**VARIANCE APPLICATION  
203 ROBERT SMALLS PARKWAY**

**STAFF REPORT**  
**203 Robert Smalls Parkway**

**CITY OF BEAUFORT  
ZONING BOARD OF APPEALS  
Staff Report and Recommendations  
Meeting of 26 October 2015**

**Case Number:** ZB15-27  
**Property Address:** 203 Robert Smalls Parkway  
**Applicant:** Navy Federal Credit Union  
**Type of Request:** Parking Variance  
**Zoning:** Highway Commercial District

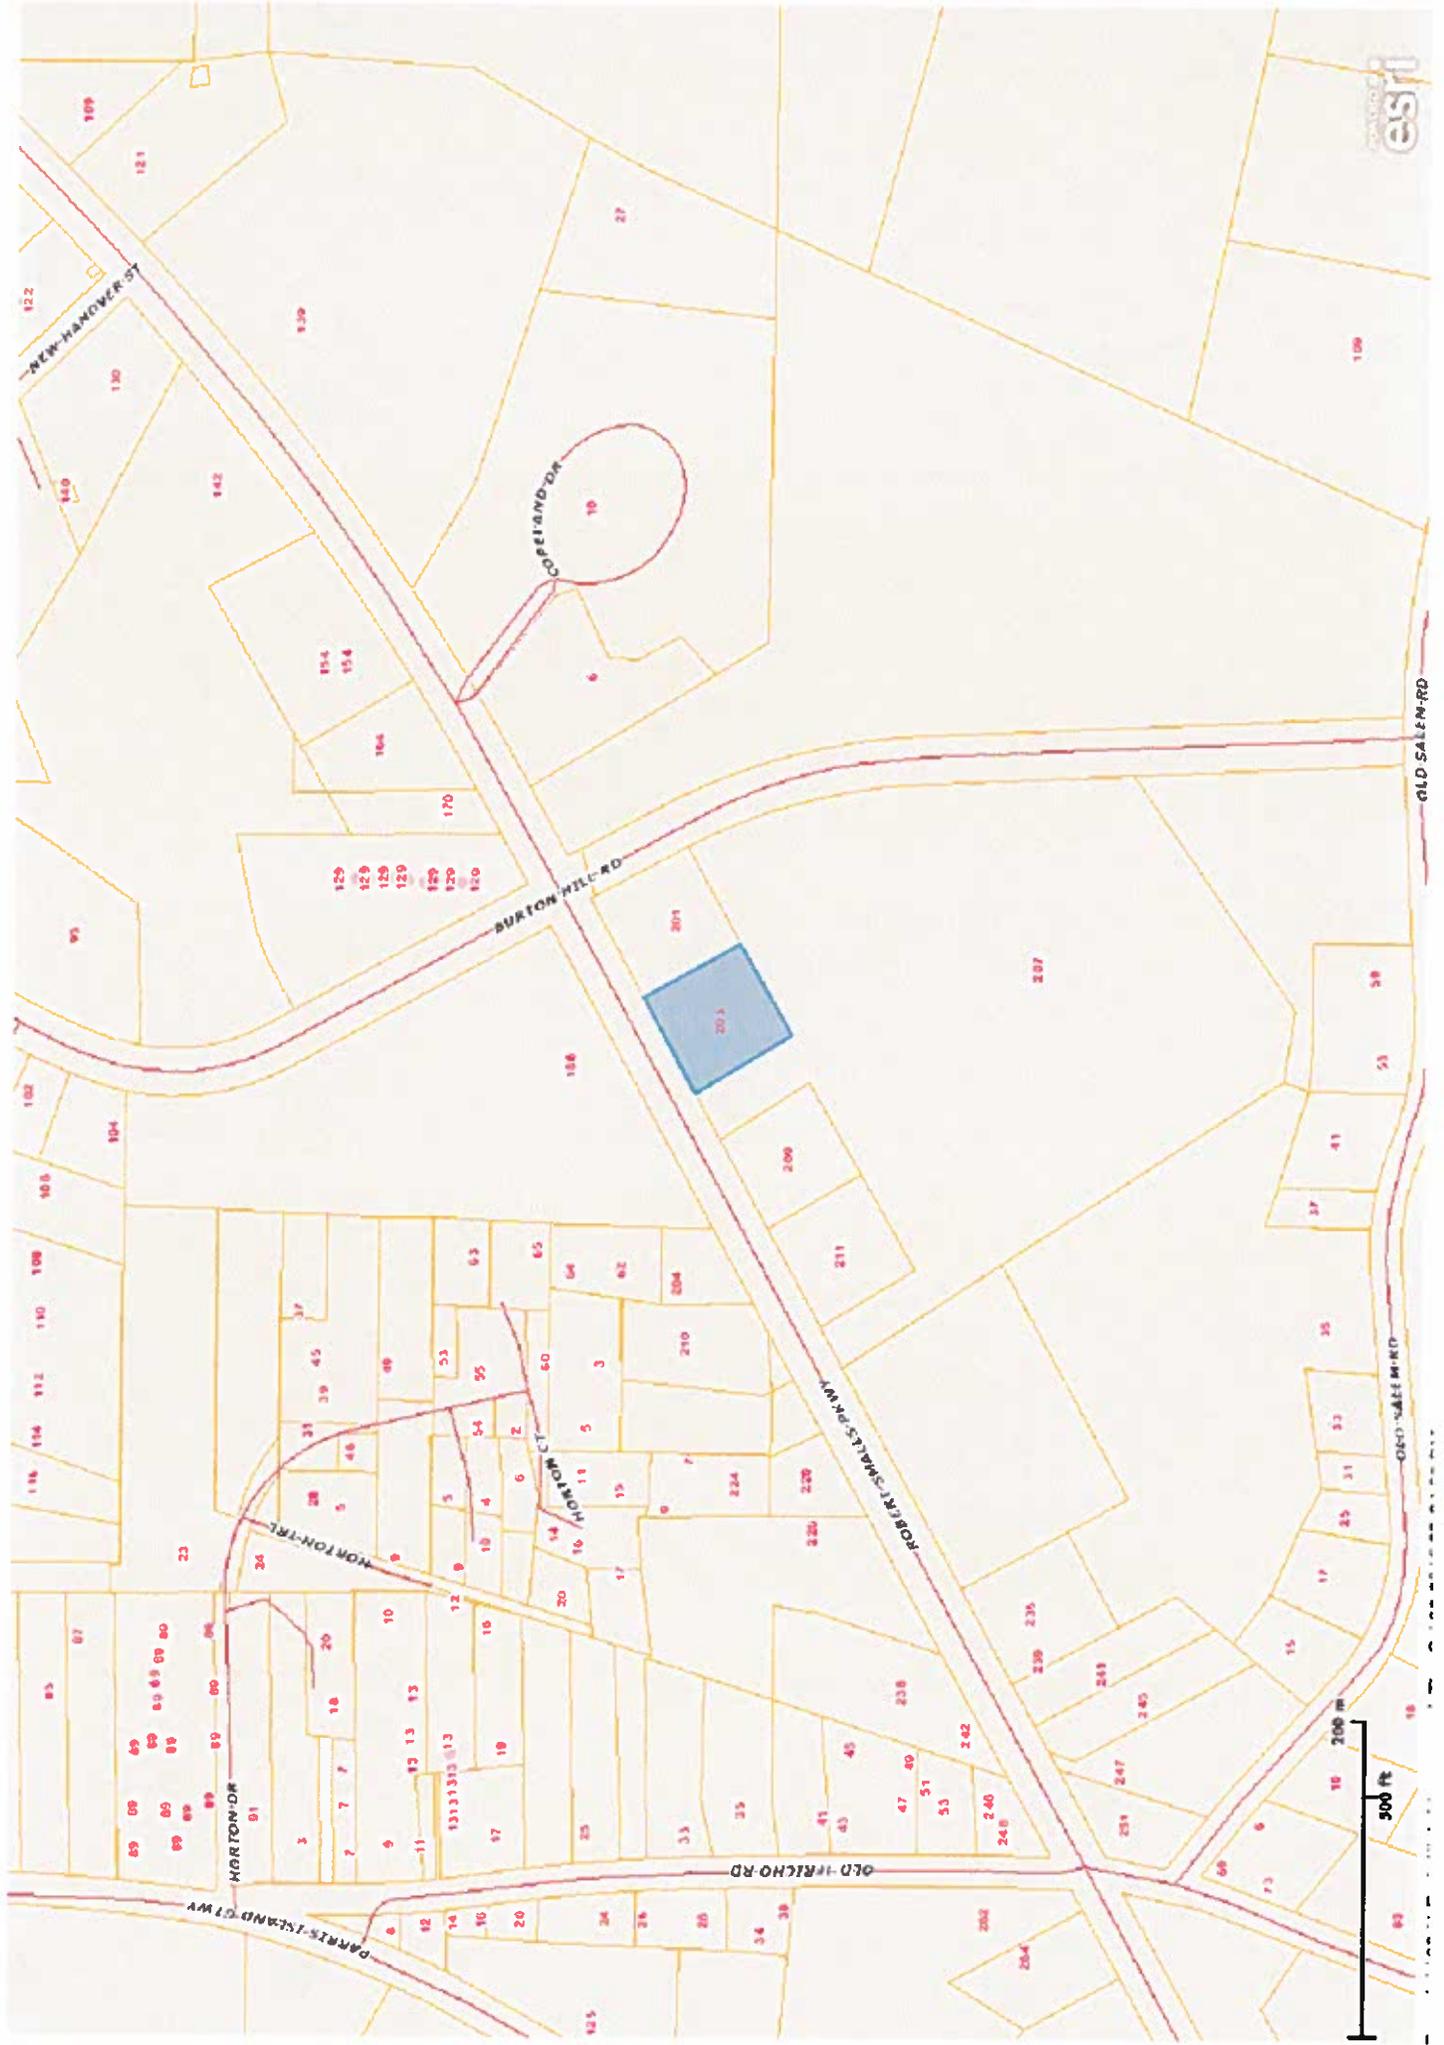
Questions for the applicant: Parking data on several branches of the Navy Federal Credit Union were provided. Does each of these facilities have two drive-thru tellers and a drive-thru ATM lane? If not, please describe the drive-thru facilities available at each branch so a better "apples-to-apples" comparison of parking demand can be made.

Are any trees over 8" DBH being removed for purposes of creating parking? If so, please describe size, species, and health.

What is the percentage of impervious surface? The limit in this district is 65%.

What is the proposed material for the pervious parking spaces?

Staff comments: The proposed 37 spaces is over 2 ½ times the minimum required by the ordinance and over twice the maximum permitted by the ordinance.

The Institute of Transportation Engineers "Parking Generation" Manual (2<sup>nd</sup> edition), suggests that a bank of the proposed size with drive-in and walk-in facilities, will have 16 occupied parking spaces on a weekday ( $3.865 \times 4.23 = 16$ ). The applicant should explain what why more than twice that number is needed in a facility that has two drive-thru tellers and a drive-thru ATM.

The three drive-thru lanes, along with the escape lane and additional parking creates a large amount of paved area. Are two drive-thru lanes necessary with the additional parking that is proposed? Could the teller drive-thru lanes be reduced to 10' and the one-way escape lane be reduced to 16'?
